**Regulation No. 43 (Safety glazing)**

### **Proposal for amendments to Regulation No. 43**

**Submitted by the expert from France\***

“Figure 1b  
Test area “A” (example of Central Driving Position)”

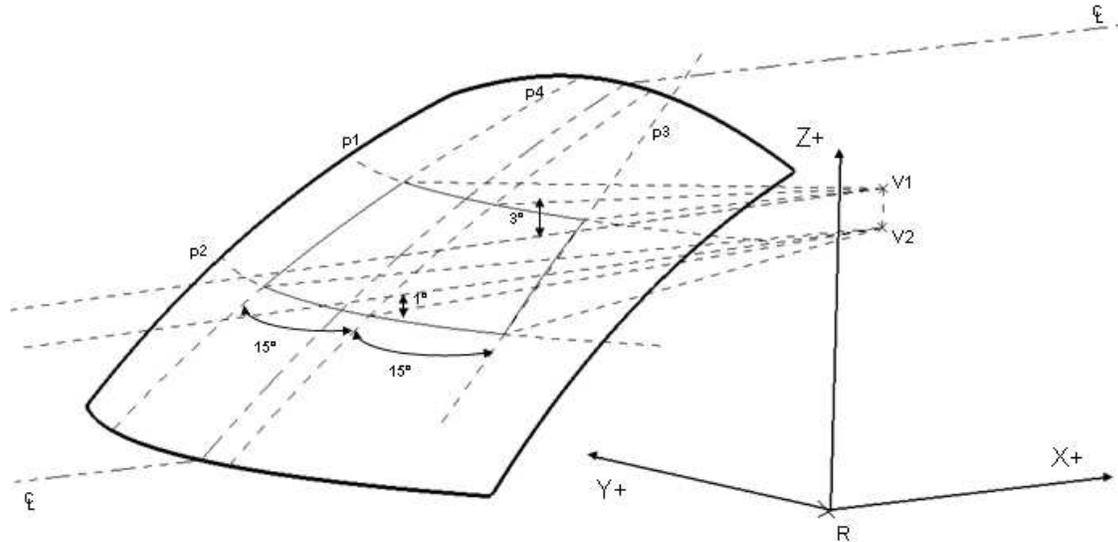
- (e) **In case of a single central driving position, two planes upwards and downwards as defined in paragraphs 2.2 (a) and (b) above and two vertical plane passing through V1 and V2 and inclined at 15° to the left of the X axis (plane 3) and 15° to the right of the X axis (plane 4) (see figure 1b)."**

Insert a new figure 1b, to read:

6. The aim of this amendment **is to include area A into area B**. It is proposed to draw an area A **with 15° to each side** (left and right). It means that area A will be larger to the left as the area A for a left-hand drive vehicle and smaller to the right. And this area is including into area B (symmetrical with 17°).

7. Using an other angle, for example 20°, will give in that case, an area A too large and outside the area B, with a possible risk to meet the A pillar,

8. This proposal allows leaving a room around area A, because area B is symmetrical with 17° and have the same situation as it is in the current ECE 43 for a left-hand drive vehicle or right-hand drive vehicle.
